## PLANNING AND ZONING BOARD STAFF REPORT

### American Social - Waivers

Meeting	File No.	Application Type
May 19, 2025	2025-090-ARC-WAI-LV1	Level 1 Site Plan Revision with CBD Waivers
Property Owner	Applicant/Authorized Agent	
Delray Trio, LLC	Miskel Backman LLP

Provide a recommendation to the City Commission on two waiver requests associated with a Level 1 Site Plan Modification for a previously approved site plan to reduce the streetscape curb zone dimension from the required 4 feet to 0 feet, and to exceed the maximum allowable awning setback encroachment from 4 feet to 9 feet and 7 inches (to abut the property line).

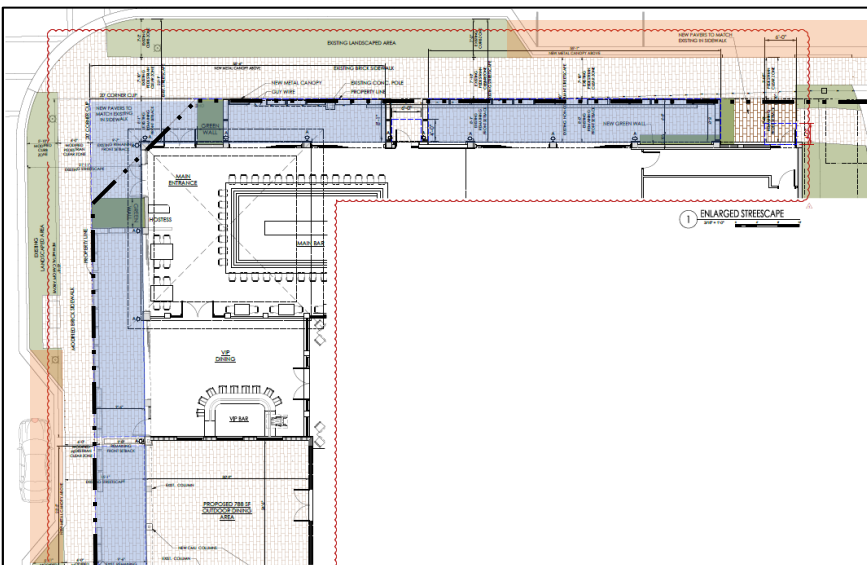
**The request is to exceed the maximum allowable awning setback encroachment of four feet to allow an encroachment of 9 feet and 7 inches**, shown in blue at right. The awnings are proposed to cantilever to the property line. The existing building has a variable nonconforming setback, and the awning will encroach **9 feet 7 inches** at the furthest point. The awning will also encroach into the ROW at the corner which will require acceptance of a hold harmless agreement, although this is not part of this subject request. Similarly, the awning will be required to meet minimum vertical clearance requirements over the sidewalk.

**The request is to omit the required four-foot curb zone, providing a curb zone width of 0 feet for a portion of the streetscape where existing on-street parking spaces are located** (shown in orange, above). While the minimum fifteen feet of total streetscape is still provided, the Applicant is proposing that the balance of the streetscape gained from the omission of the curb zone be redistributed to the pedestrian clear zone and remaining front setback area, with an intended use as an expanded outdoor dining area (subject to separate review and approval under the sidewalk café program).

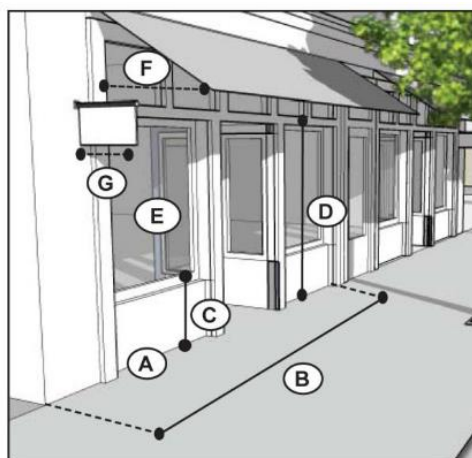
The applicant is requesting to exceed the maximum awning setback encroachment of four feet along the north and west façade adjacent NE 1<sup>st</sup> Street and NE 2<sup>nd</sup> Avenue. The required setback for the property is a minimum of 10 feet and maximum of 15 feet. The existing structure is nonconforming with a setback that ranges from 8 feet to 8 feet and 1 inch for the north façade, and 9 feet and 6 inches to 9 feet and 7 inches for the west façade.

The proposed awning would cantilever over the outdoor dining seating and would extend to the property line, encroaching approximately 8 feet in depth for the north façade and 9 and a half feet in depth for the west façade. (Note: The outdoor dining requires review and approval through the sidewalk café permit process).

Due to the required 20' by 20' corner clip dedication at the intersection of NE 1<sup>st</sup> Street and NE 2<sup>nd</sup> Avenue, the existing structure will encroach slightly into the public ROW at the corner. A hold harmless is required for the existing structure and the proposed awning overhang within the public ROW.

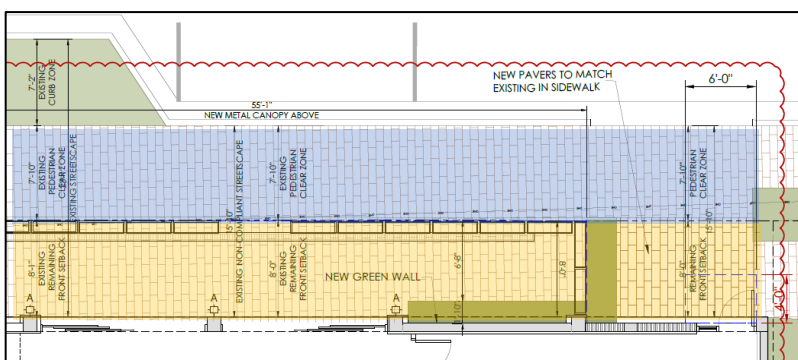
The proposed streetscape meets the minimum dimensional requirements for most of the subject site, providing continuous sidewalk, street trees and lighting. However, the applicant is requesting to reduce the curb zone width from the required remaining 4 feet to 0 feet adjacent to on-street parking spaces. The curb zone is measured from the back of curb to the pedestrian clear zone and typically accommodates street trees and public infrastructure needs such as utility poles, streetlights, street signs, parking meters, etc.

The pedestrian clear zone, depicted in blue, and the remaining front setback, depicted in yellow, complies with the required dimensions along the areas seeking curb zone relief; west façade proposes a 6-foot pedestrian clear zone and 9-foot remaining front setback, and north façade proposes a 7-foot 10-inches pedestrian clear zone and 8-foot remaining front setback. The overall streetscape dimensions comply with the required 15 feet throughout the site. Likewise, the Applicant has proposed the addition of three shade trees where none currently exist along NE 1<sup>st</sup> Street within the portion of the streetscape where the curb zone is provided. This is a clear improvement in quality over the existing conditions.
